END STATION "B" FLOOR PLAN

## VEAY LLO Existing Cable Piers Locations

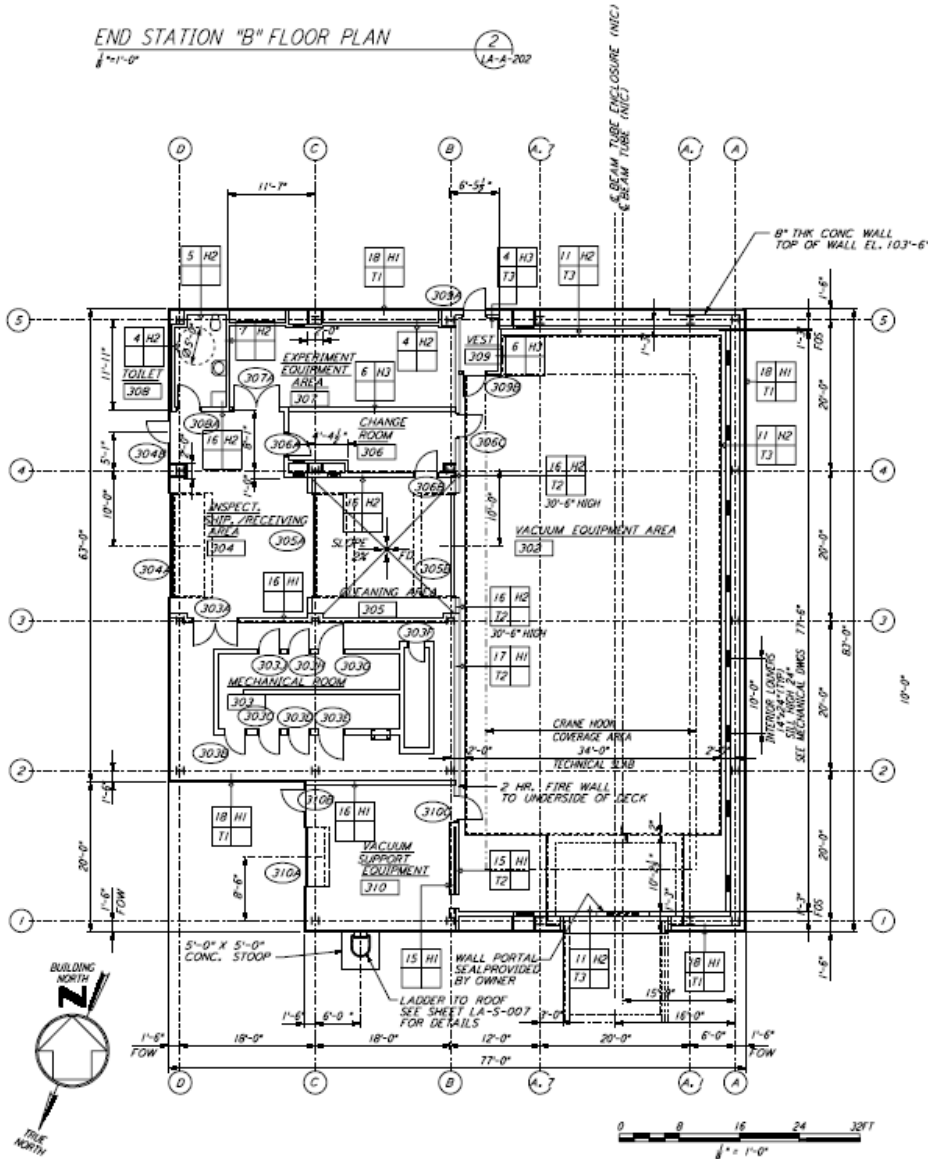
- 1) Where does 11U Short Rack (D1001423-v11) go? (Ignore)
- 2) Where does L1-AOS-YR1 (if it needs to exist) go? (Does not exist)
- 3) What does pentagon-2 mean regarding tray removal? Is there tray across the beam tube from L1-SUS-YR1? (Ignore)
- 4) Is the called-out 10' height important for some reason? LLO height is 8'. (OK)
- 5) What are the double doors in the note all about? (Ignore)
- 6) A door is missing from the garb room to the VEA. (Ignore)
- 7) The doors are missing from the mechanical room. (Ignore)
- 8) L1-VAC-YR1 is missing. (Shown)
- 9) All cabling that currently uses under-beam tray and the waterfall is missing. (Kurt)
- 10) The Photon Calibrator is missing. (Mounted to tube - part of OPLEV)
- 11) VE Pumps are not shown. (Shown)
- 12) Size of ISCB5R is not specified. (72 x 48)

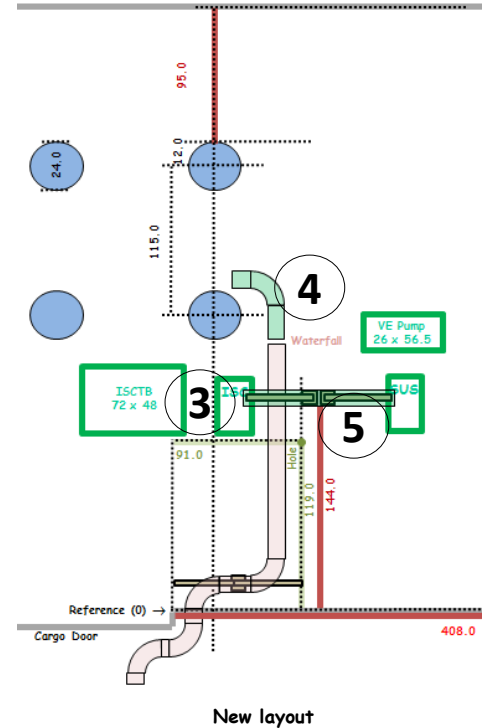
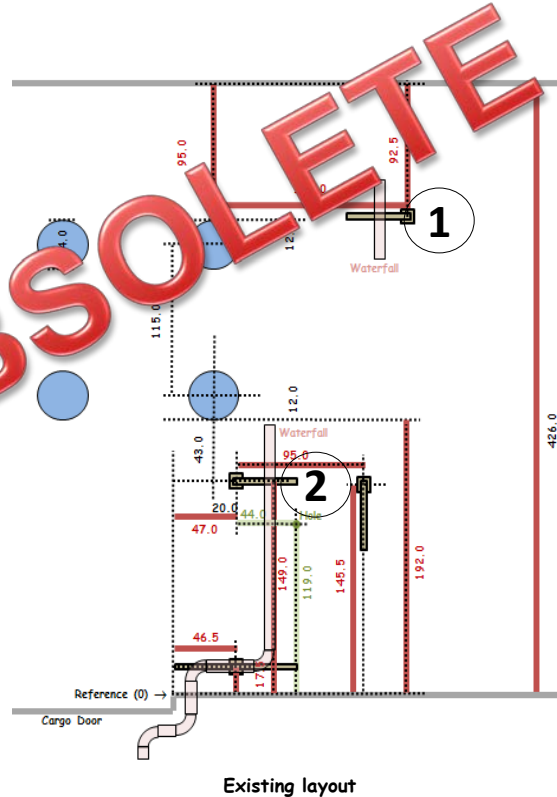
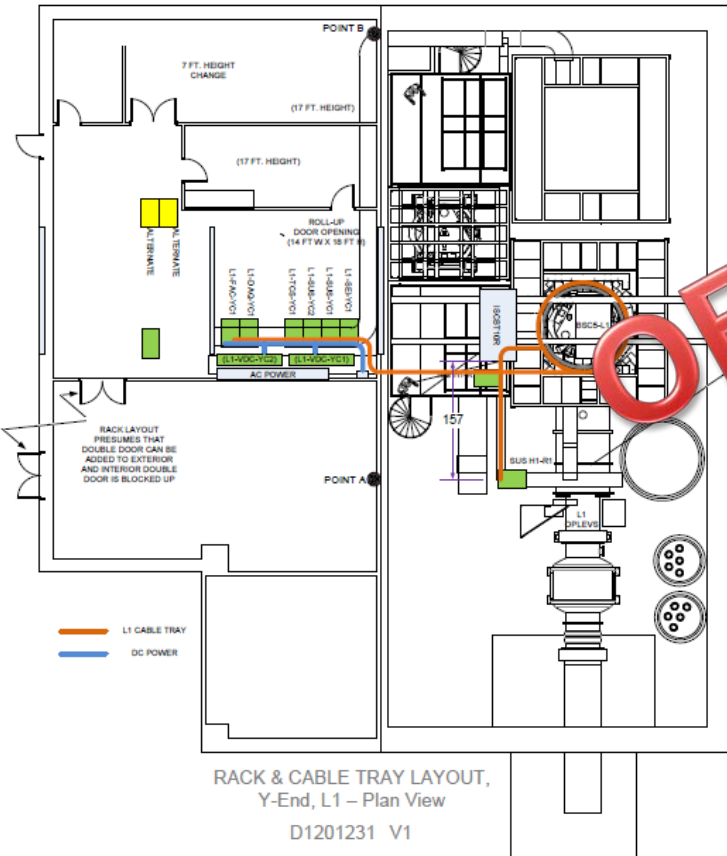
- 1) Remove old cable tray and pier that interferes with dome parking.
- 2) Relocate existing piers to support cable tray to L1-SUS-YR1.
- 3) Locate L1-ISC-YR1 farther away from existing pier for clearance.
- 4) Suggest joining basket around BSC to existing cable tray at waterfall.
- 5) Add cable tray to reach L1-SUS-YR1.

It is 65' from the L1-FAC-YC1 Rack to the knee of the waterfall in the VEAY.  
The height of the cable trays is 8'.
